ALASKA NATURAL GAS TRANSPORTATION SYSTEM

FINAL GEOTECHNIC EVALUATION

ALASKA PIPELINE

Applicant: Alaskan Arctic Gas Pipeline Company

Figure 1. Construction Equipment Noise Ranges

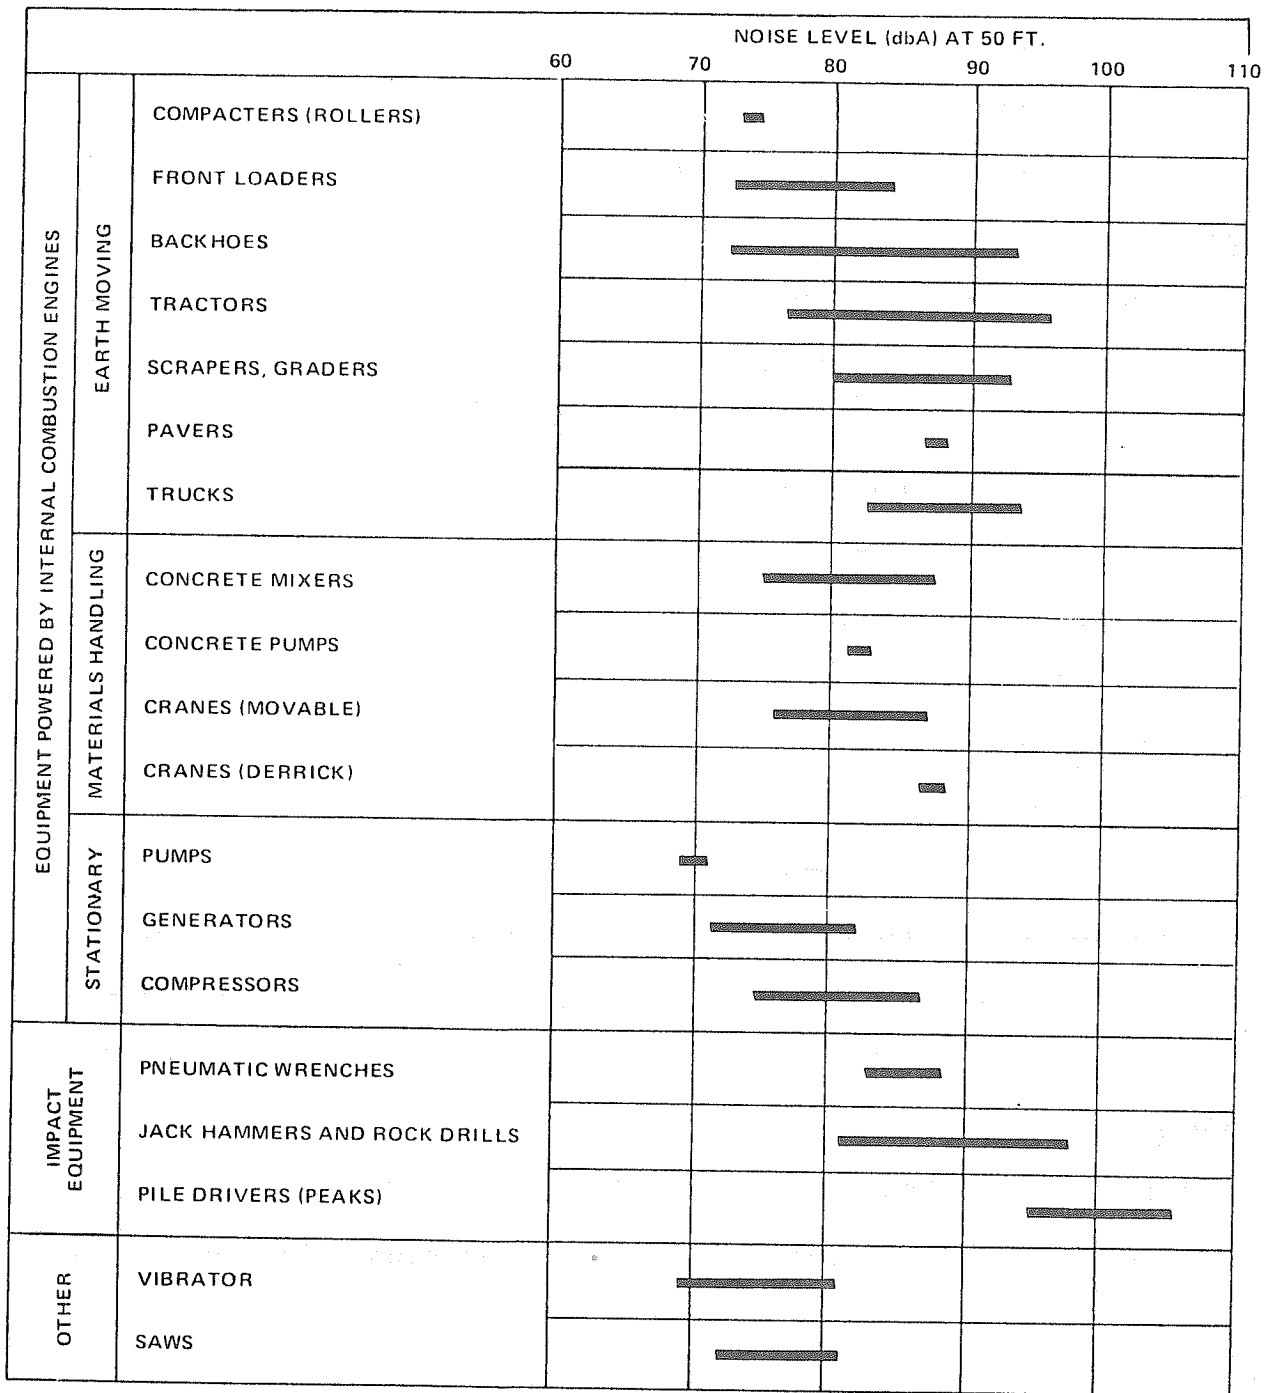
The construction noise and its effect on the environment may be underestimated by the Applicant. Figure 1 shows some typical construction equipment noise ranges. Construction would take place in an environment with very low background noise. It would involve movement of people, heavy equipment, trenching, blasting and drilling, pipe laying and backfilling.
